From: Ian Lucas ilucas@smitherspurslow.com
Subject: RE: 51/2016/0882 - IWL - Manchester Jewish Museum: Vestibule Floor
Date: 30 November 2020 at 13:07
To: Candice Moore candice@citizensdesignbureau.net
Cc: Katy Marks (Citizen Design Bureau Architects) katy@citizensdesignbureau.net

Manchester Jewish Museum: Vestibule Floor

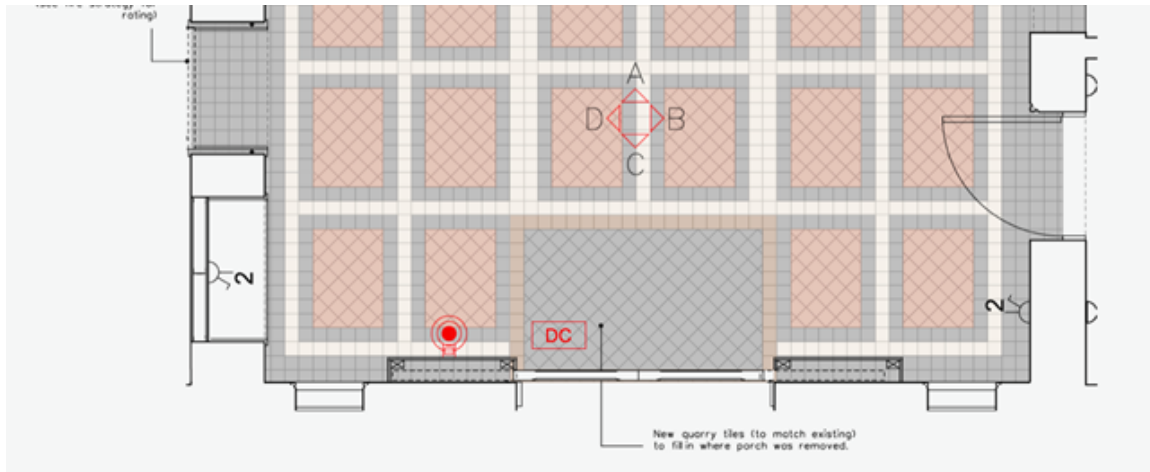
Further to your response below I just wanted to highlight that the new inlay tiles would be done so they look like a welcome mat and rather than trying to blend in.

They will also be laid at a 45degree angle rather than laid in the same grid.

See below our intension.

Is this something you could support?

Thank you for your emailed note of earlier today. I absolutely approve of the proposal to install the new tiling to resemble a welcome mat... and to treat it differently but to the same quality as the remainder of the tiling. This is an excellent approach to historic fabric.
